June 24, 2015

Re: CGS Response Letter and Proposed Phase II Scope of Geotechnical Services
Bates Student Housing Project
702 Cragmor Road
Colorado Springs, Colorado
Terracon Project Number: 23155012

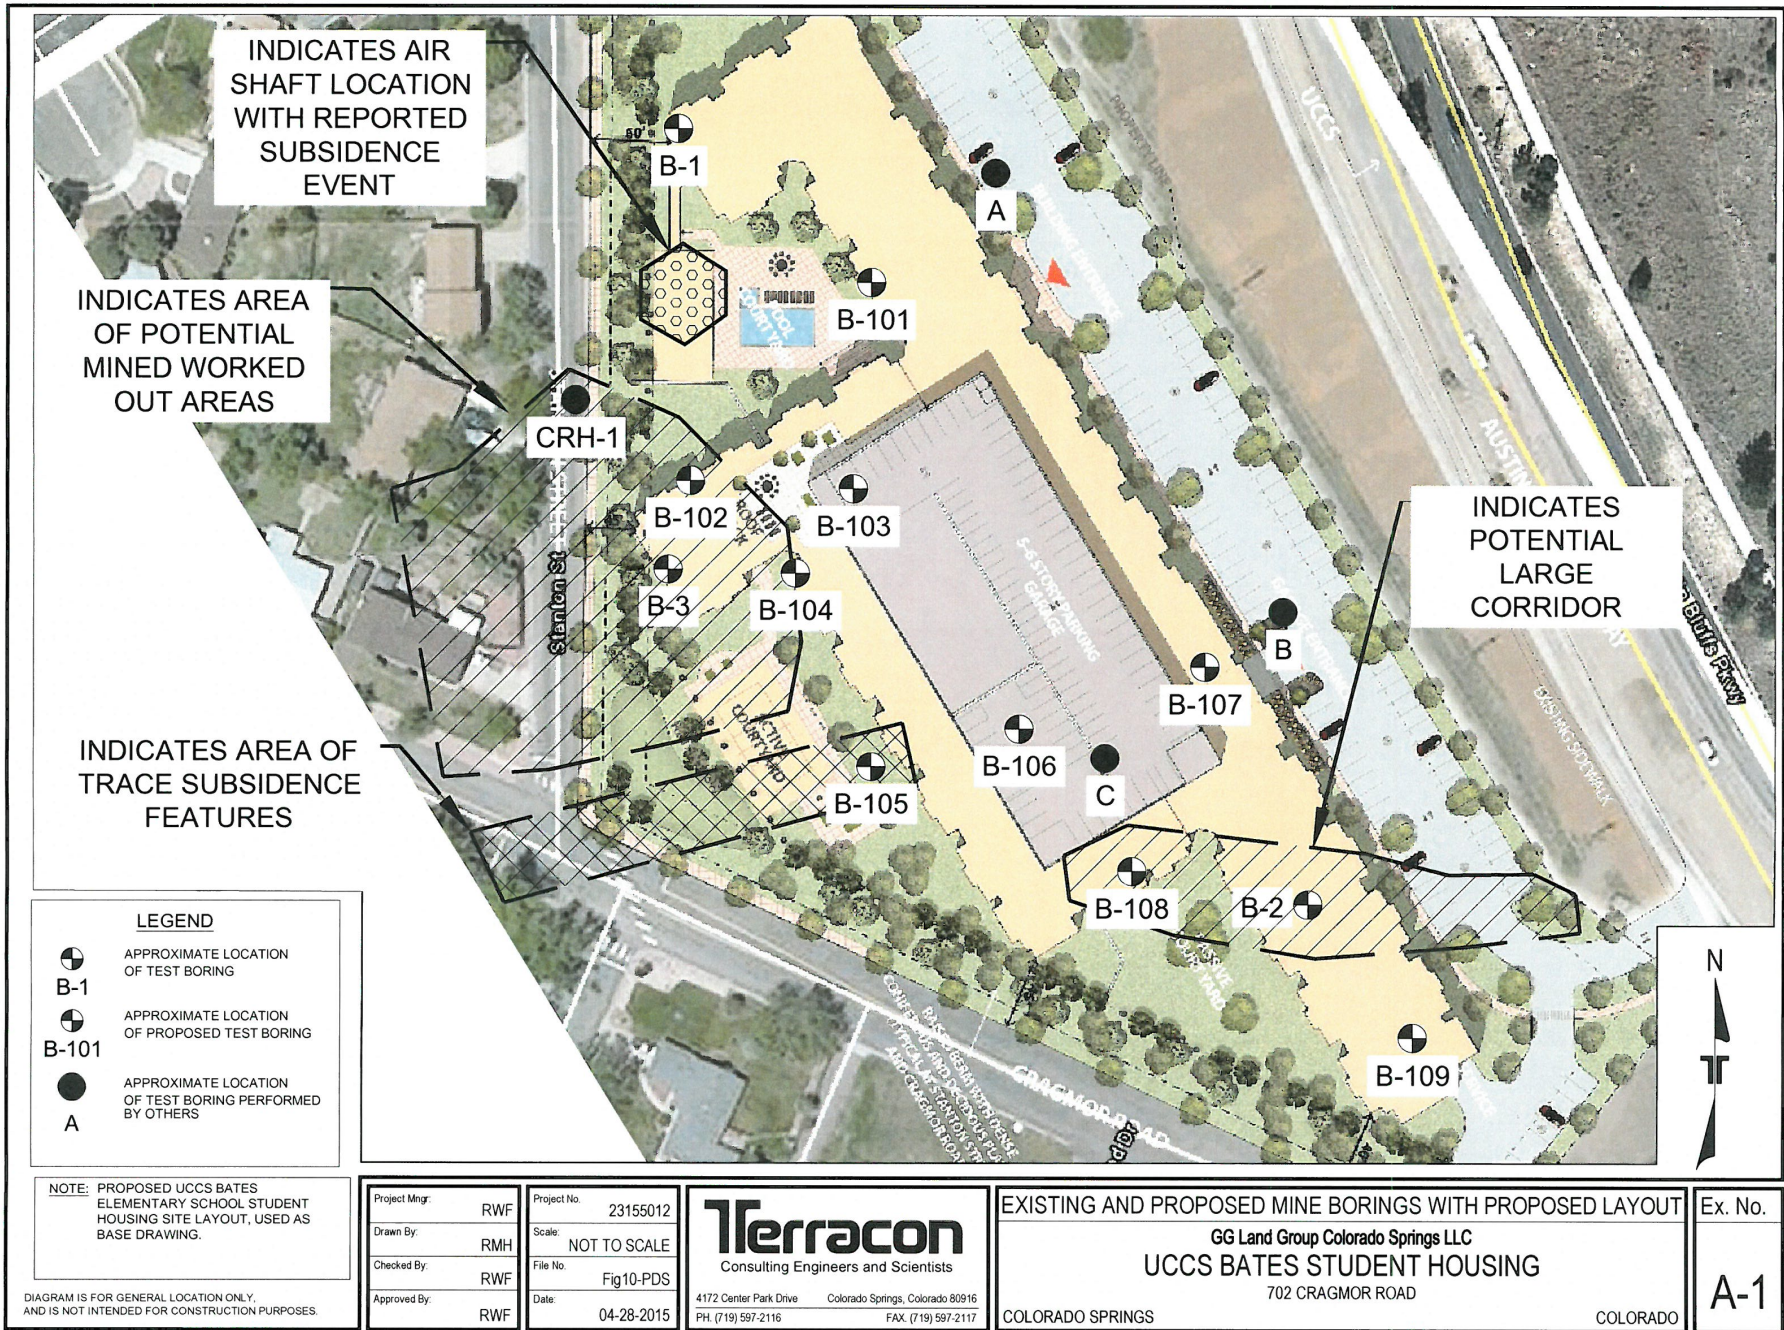
CGS Comment: *Terracon's three deep borings are insufficient to adequately characterize the condition of mine workings, voids, and subsidence hazard for a structure this large. CGS agrees with Terracon that additional borings on approximately 40-50 ft spacing within and around the footprints of all proposed structures will be needed to adequately characterize the subsidence hazard on this site.*

We concur with CGS that three borings are not sufficient to characterize the site with respect to mine activity. The borings were part of our initial phase of exploration with the intention of performing supplemental borings at a later time. We do not agree with the 40 to 50-foot spacing of borings within all building footprints. As indicated in our report, it is our intention to perform relatively closely spaced borings, at about 50 feet apart, at the locations where the designated worked out mine areas overlap the proposed building improvements only. If the supplemental borings indicate unfavorable results, we will recommend additional borings. We are proposing to perform approximately 8 to 10 supplemental mine borings as shown on the attached Exhibits A-

1 through A-4. Similarly to the initial three borings, we plan on performing gamma, caliper, and density logging of the borings.
